Environmental Services - Water Quality
Onsite Wastewater Scan Data Entry Form

WAKE COUNTY HEALTH DEPARTMENT SEPTIC TANK LAYOUT AND PERMIT

LOCATION At end of Maple Drive

SUBDIVISION NAME Cassidy Subdivision LOT NO. 73 & 72 SECTION OR BLOCK NO.

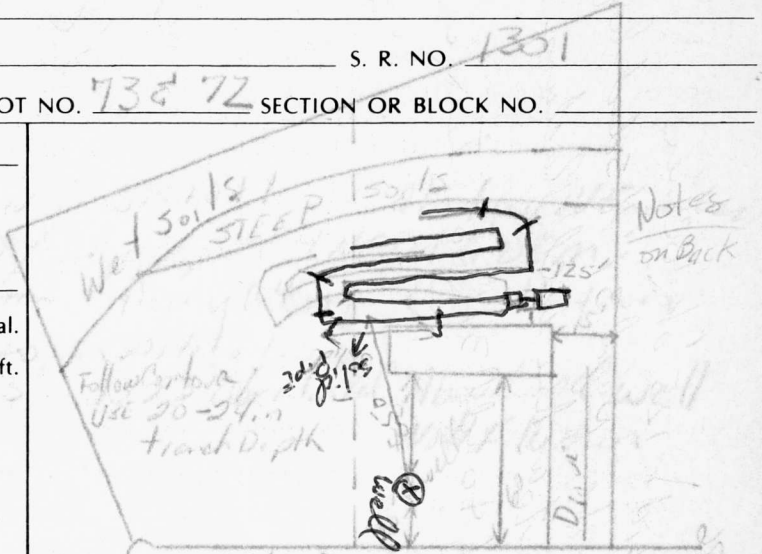
① Inside 125' ok to Corner

② Outside Need 37' of solid before S.P. to achieve well Radius

③ Need to add 37'Ⓓ to outside
